PRE-APPLICATION MEETING MINUTES

1660 Mission Street, Meeting Date April 15, 2026, 2pm (Virtual TEAMS mtg.)

1660 Mission Street (Assessor Blk. 3512/Lot 005)

1660 Mission Street is an existing Type II-A, B-occupancy, six-story building, under 75' in height, over a basement, approximately 103,000 square feet, formerly occupied by DBI and other City functions, currently vacant, and proposed for renovation for Department of Public Health uses. The building includes a basement parking level, Levels 1 through 6, and a rooftop mechanical penthouse.

BASEMENT FLOOR
 TITLE:
A-B
 SHEET:

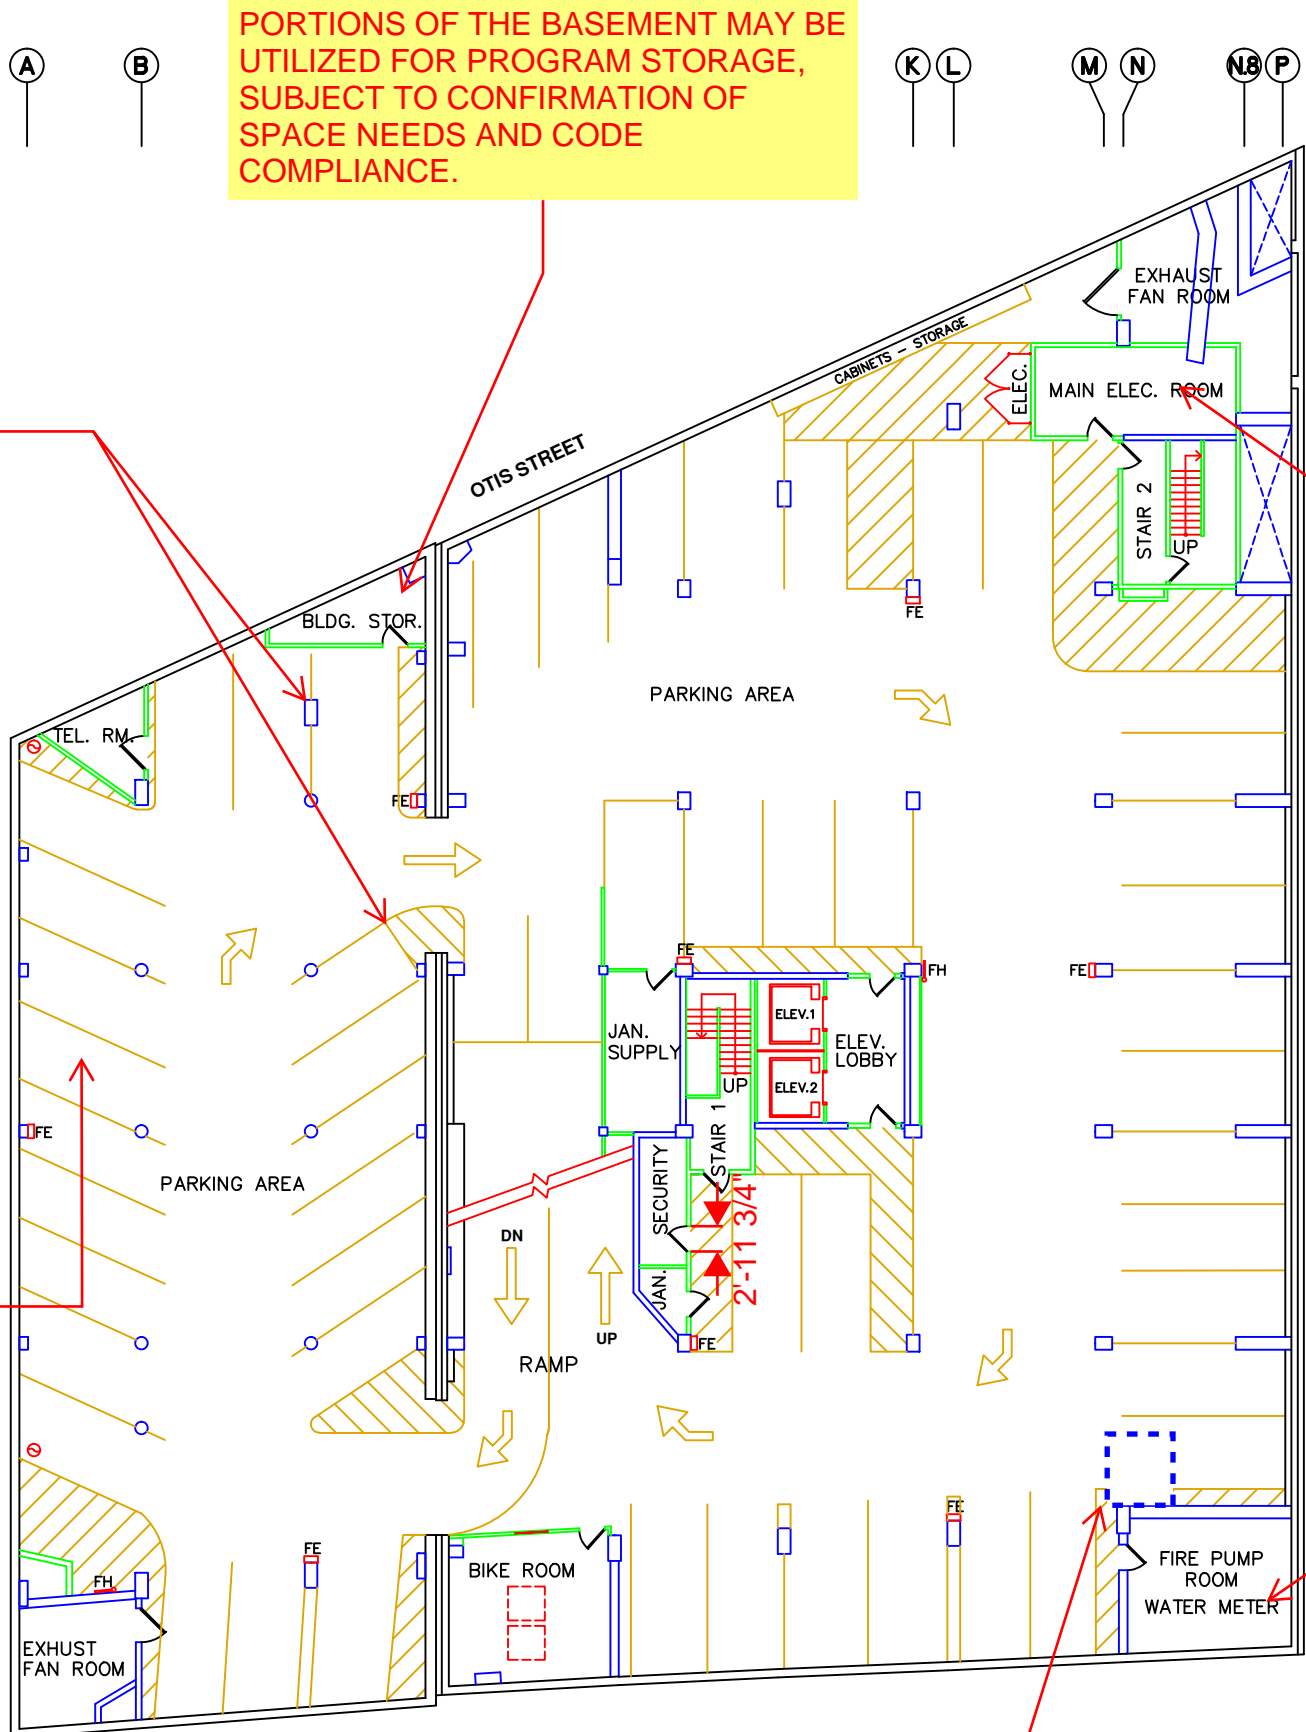
LOCATION OF ELEVATOR ABOVE - QUESTION #11

DBI stated that the proposed convenience stair and shuttle elevator do not automatically trigger a mandatory seismic upgrade simply by virtue of being new openings. However, DBI stated that the work must be evaluated for its local structural effects, including whether the new openings or redistributed loads cause any affected element to exceed the applicable 5% gravity / 10% lateral threshold before and after the alteration. If those thresholds are exceeded, structural analysis and any required strengthening would be required. (SFBC §503.11; SFBC §§~~304.3.2, 304.4.3~~; CEBC ~~§805.3~~ 503.3 & 503.4)

SECOND FLOOR

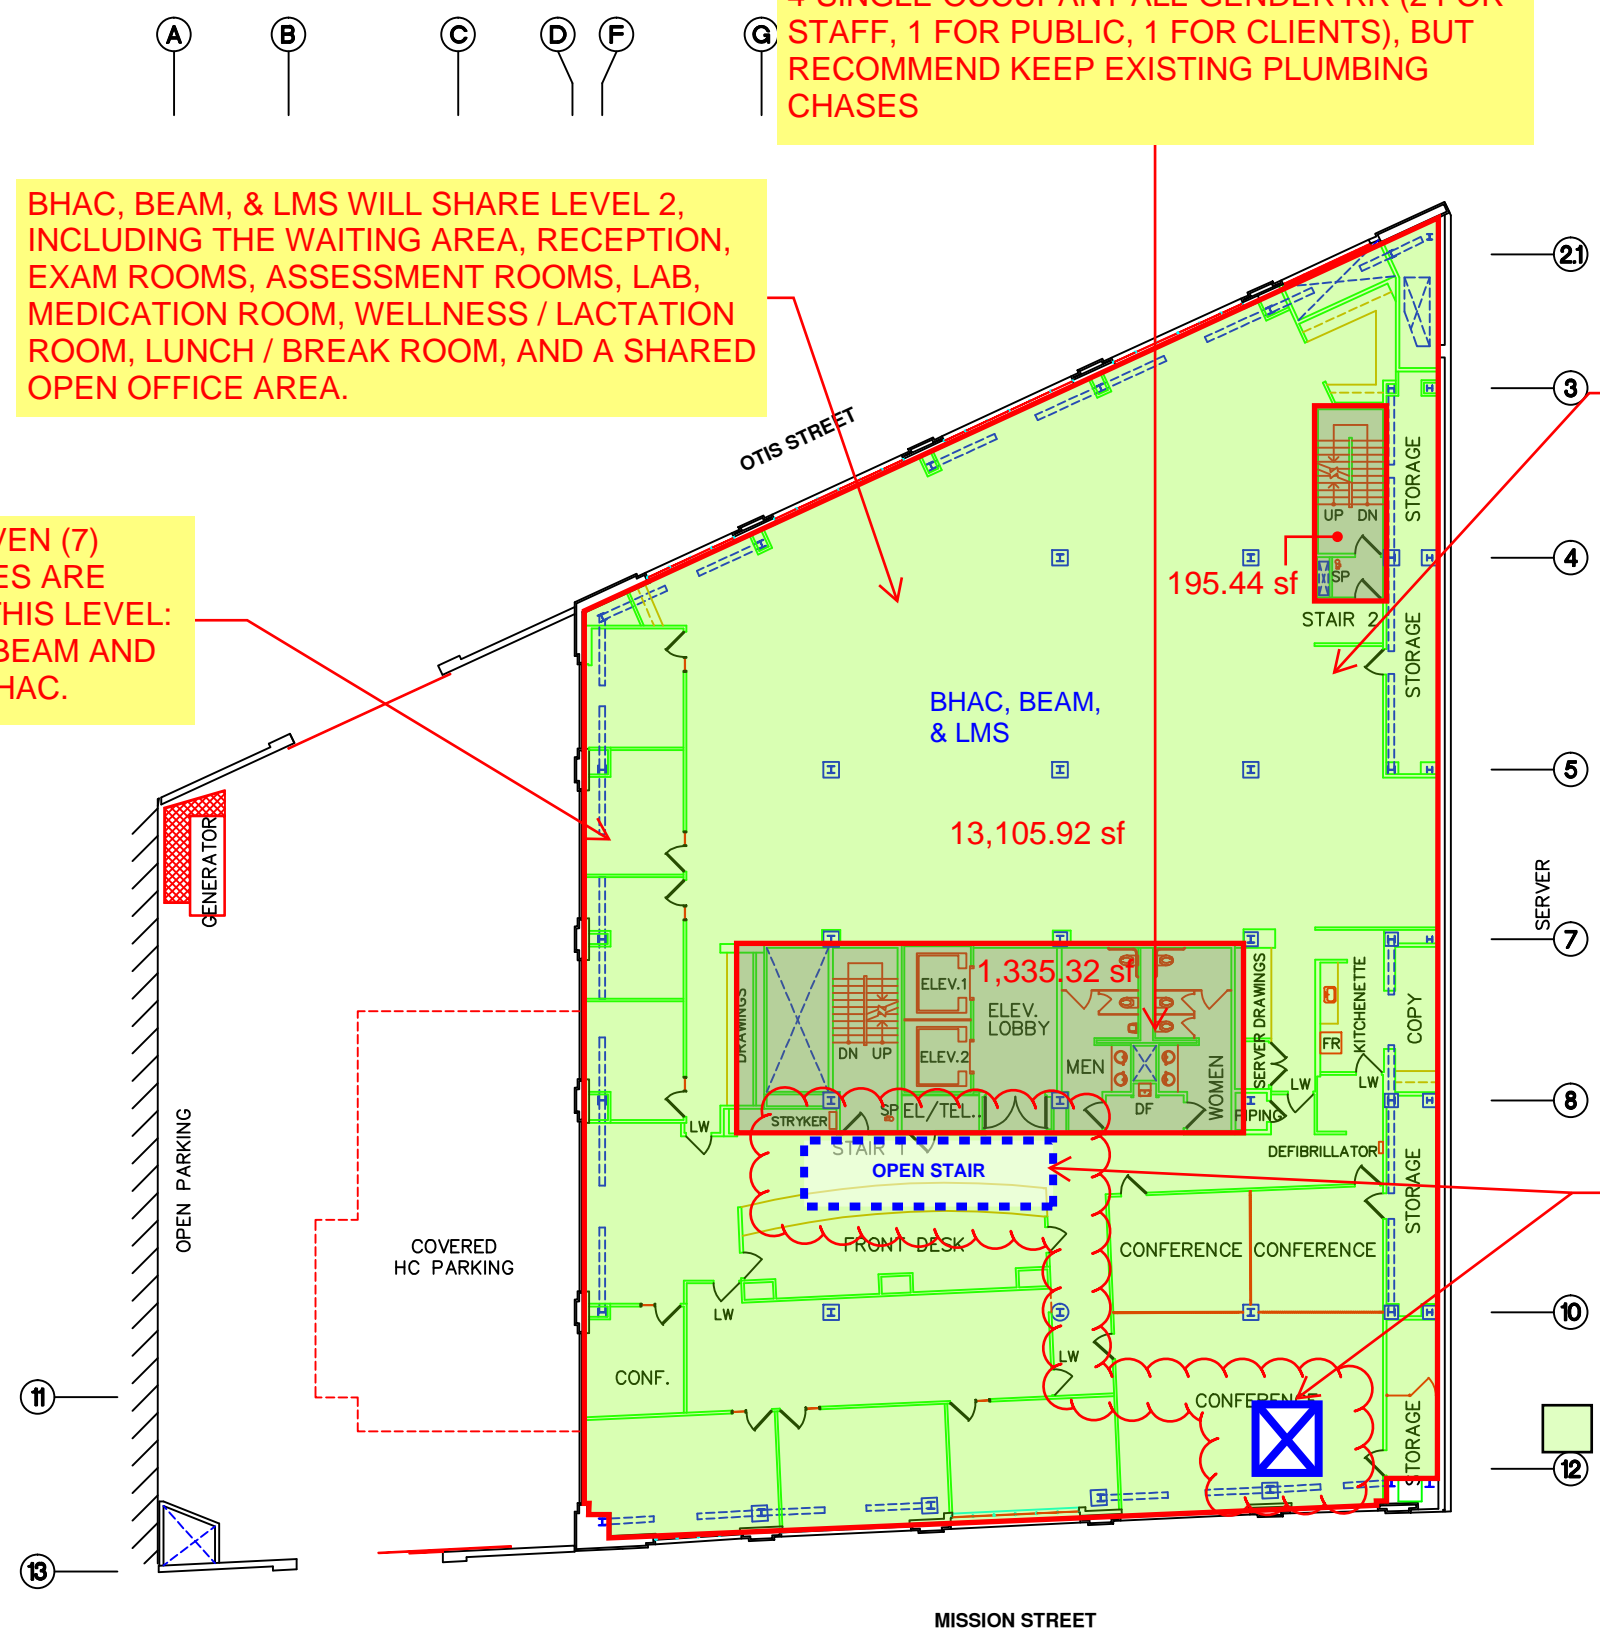
SHUTTLE ELEVATOR AND CONVENIENCE STAIR - QUESTIONS #11&12

THE EXISTING OPEN OFFICE AREA ON THIS LEVEL IS A STRONG CANDIDATE FOR MINIMAL OR NO INTERVENTION AND SHOULD BE TARGETED TO REMAIN LARGELY UNMODIFIED TO SUPPORT THE LESS THAN 2/3's COMPLIANCE STRATEGY.

DBI and SFFD stated that the open convenience stair may connect two levels, but that if it connects more than two stories, the project would need to comply with the applicable atrium / vertical opening provisions. DBI specifically referenced the code path under which only the two lowest stories may be open to the atrium,

while any story above must be separated from the atrium in accordance with the shaft provisions. **(CBC §§404.4, 404.5 Exception 2, 713.4)**

DBI and SFFD indicated that, for the proposed condition, one compliant approach would be to keep the lowest two levels open and separate the third floor from the opening in a manner equivalent to a shaft enclosure. Under that approach, smoke control may not be required. If the upper level is not properly separated, smoke control would likely be required. **(CBC §§404.5 Exception 2, 404.7, 713.4)**

THIRD FLOOR
TITLE:
A-3
SHEET:

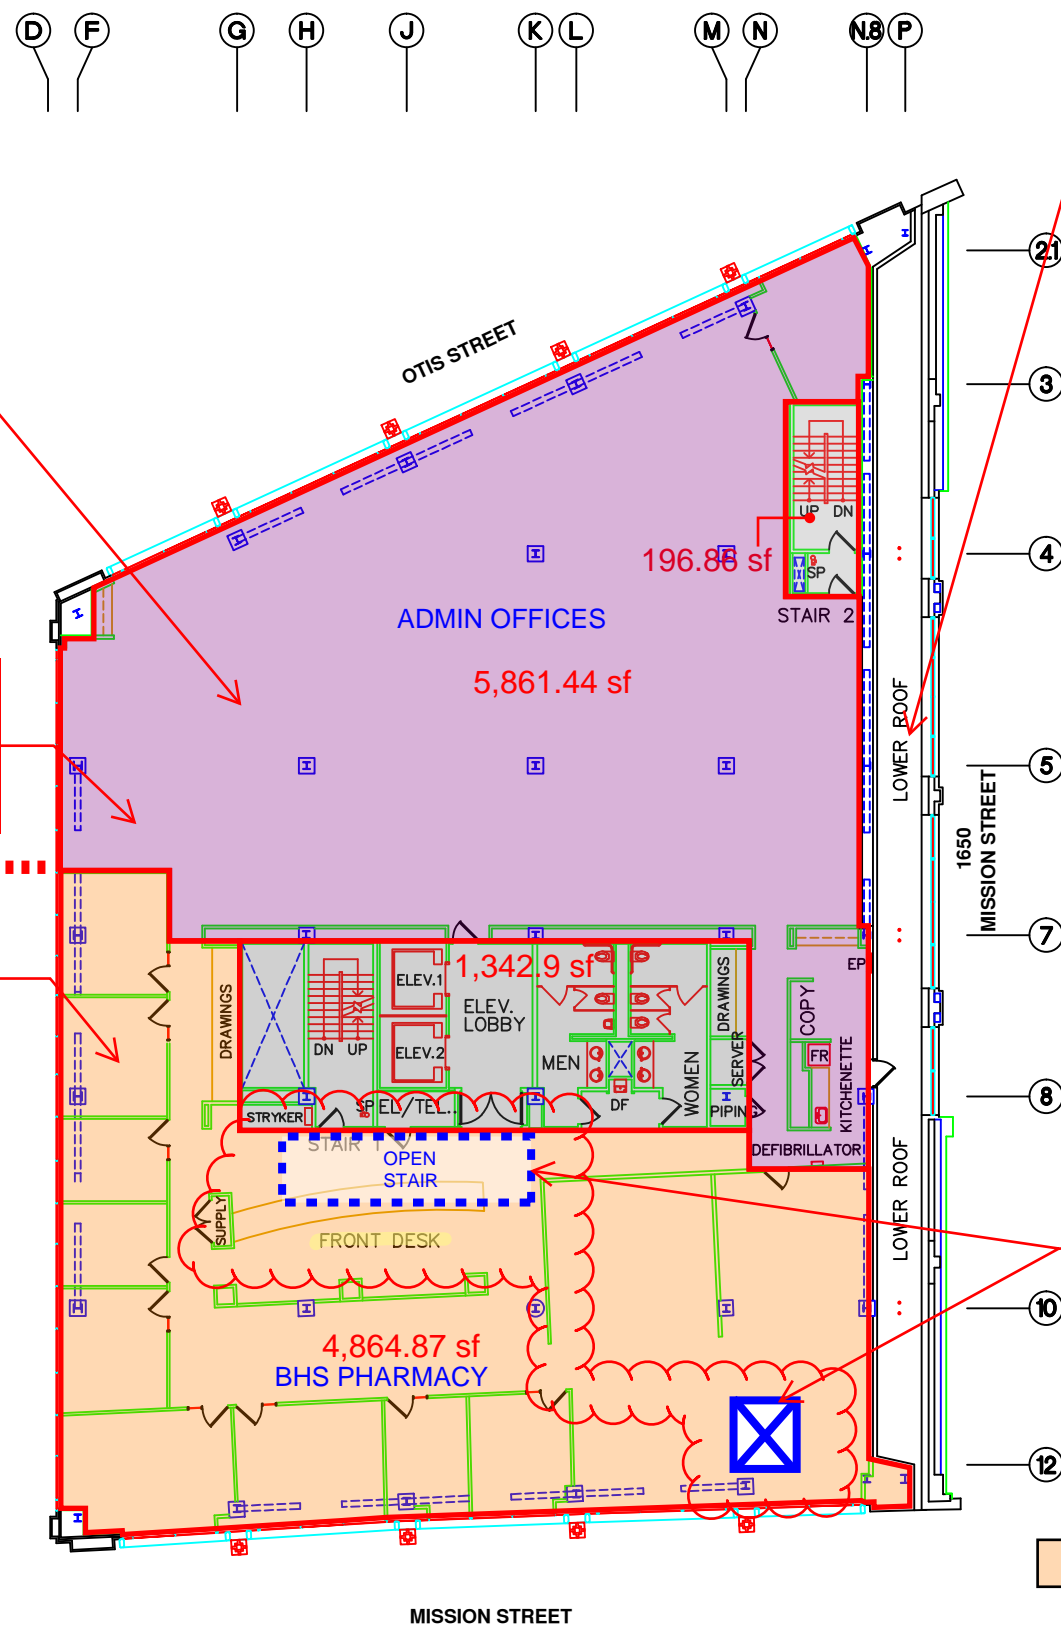
LIMITED COMPLIANCE / TARGETED WORK AREA - REFERENCED IN Q3, Q6, Q7, & Q8

SHUTTLE ELEVATOR AND CONVENIENCE STAIR - QUESTIONS #11&12

DBI stated that limited accessibility, path-of-travel, life-safety, and similar work is still alteration work if it requires a permit and is not exempt under SFBC Chapter 1. Accordingly, such work would count toward the analysis if it affects walls, partitions, or ceilings beyond the threshold described in Response to Question 1. DBI further stated that if certain finish work or similar items are exempt from permit under SFBC Chapter 1, such exempt work would not be counted. **(SFBC §304.4 ~~304.5~~; SFBC §106A.2)**

DBI recommended that the minutes avoid using the term “trade permits” loosely and instead refer to MEP addenda or deferred separate permits, as applicable. DBI stated that mechanical, electrical, plumbing, fire alarm, and sprinkler work are not themselves listed elements under the story-count analysis. Therefore, such work does not count toward the threshold unless it results in actual alteration of walls, partitions, or ceilings. DBI gave the example that local removal and replacement of an acoustical panel ceiling system for MEP access would count only to the extent of the actual ceiling disturbance. (SFBC §304.4 ~~304.5~~; SFBC §106A.3.4.2 ~~3~~)

DBI stated that the relevant timing is tied to the completion and inspection signoff of work scope in the permit /final approval, not simply the date the original site permit application was filed. DBI explained that the intent of the provision is to prevent applicants from circumventing the substantial alteration threshold by spreading related work over time a number of consecutive permit applications. DBI stated that the clock is understood in relation to when the work is completed and finalized.

DBI and SFFD indicated that sprinkler and fire alarm work do not, by themselves, control the story-count analysis unless the work results in actual alteration to the listed elements — walls, partitions, or ceilings —

TITLE:
A-4
 SHEET:

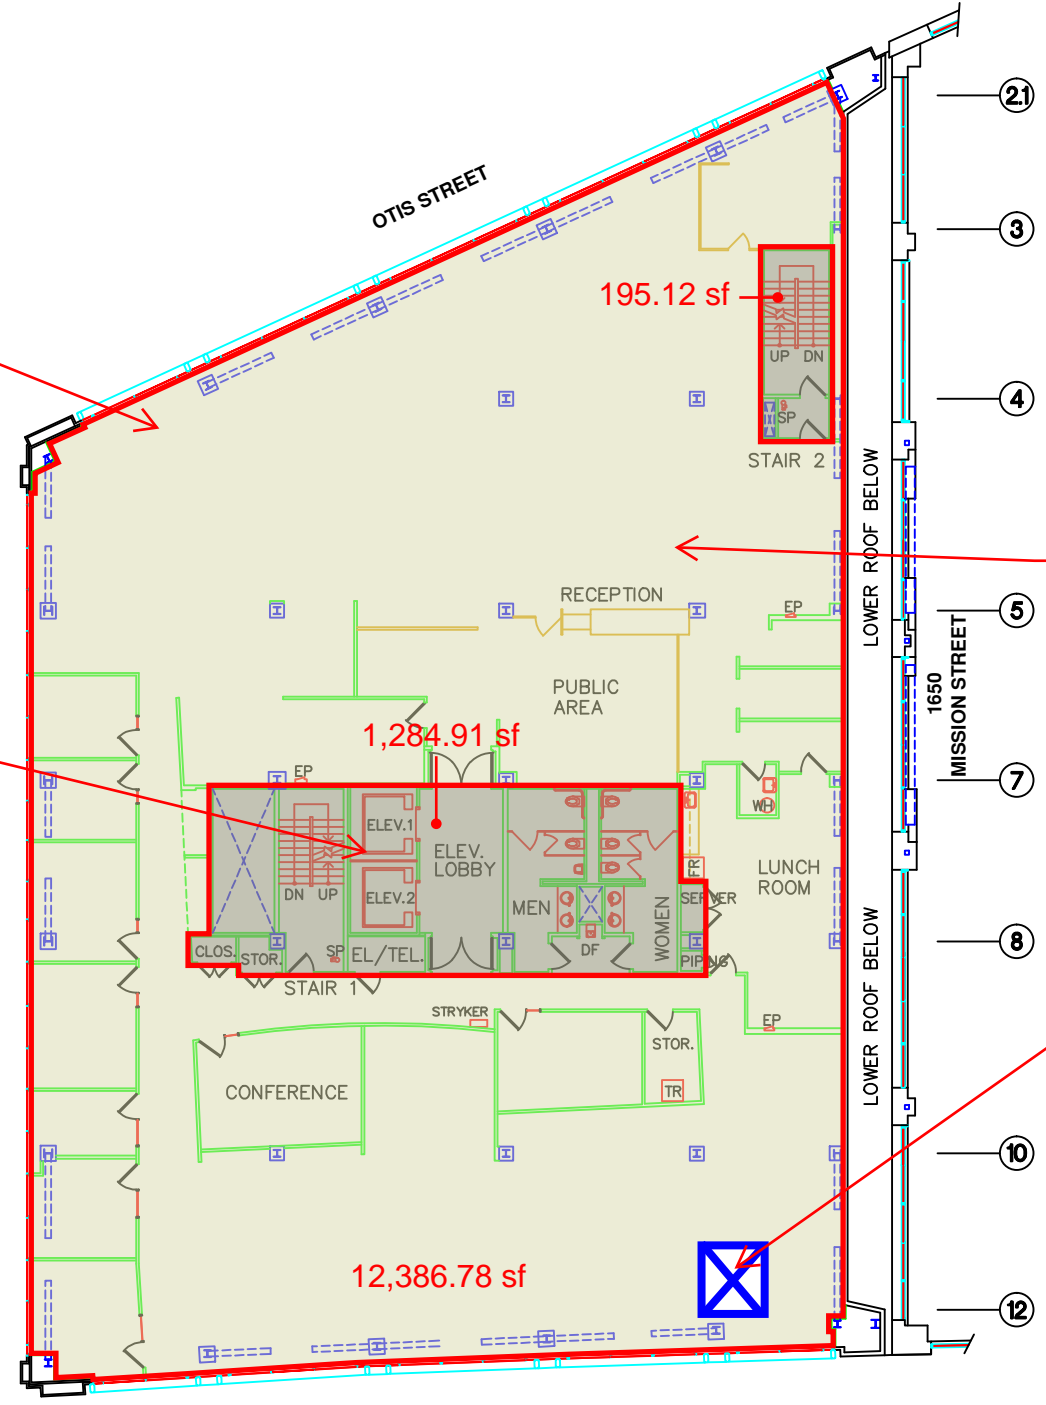
SHUTTLE ELEVATOR - QUESTION #11

FIFTH FLOOR

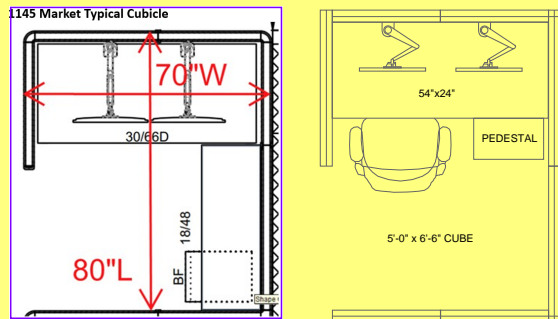
LIMITED COMPLIANCE / TARGETED WORK AREA - REFERENCED IN Q3, Q6, Q7, & Q8

EXISTING KITCHENETTES / CASEWORK IF RELEVANT TO EXEMPT-WORK - QUESTIONS #4&5

DBI stated that permit-exempt work under SFBC Chapter 1, §106A.2 does not count toward the story-count analysis. DBI cautioned, however, that some items described as “finish work” may still require a permit depending on the actual scope. (SFBC §106A.2; SFBC 304.4 ~~304.5~~)

With respect to counters, casework, built-ins, desks, and similar non-structural millwork, DBI stated that those items may count toward valuation, but are not necessarily treated as wall / partition work unless they are attached to a partition such that the work also alters the partition. If casework or counters are attached to a partition, the partition work would count. If the work is only casework or counters by themselves, DBI indicated that it would generally not be treated as wall / partition work for purposes of the story-count analysis. (SFBC §106A.2(4); SFBC 304.4 ~~304.5~~)
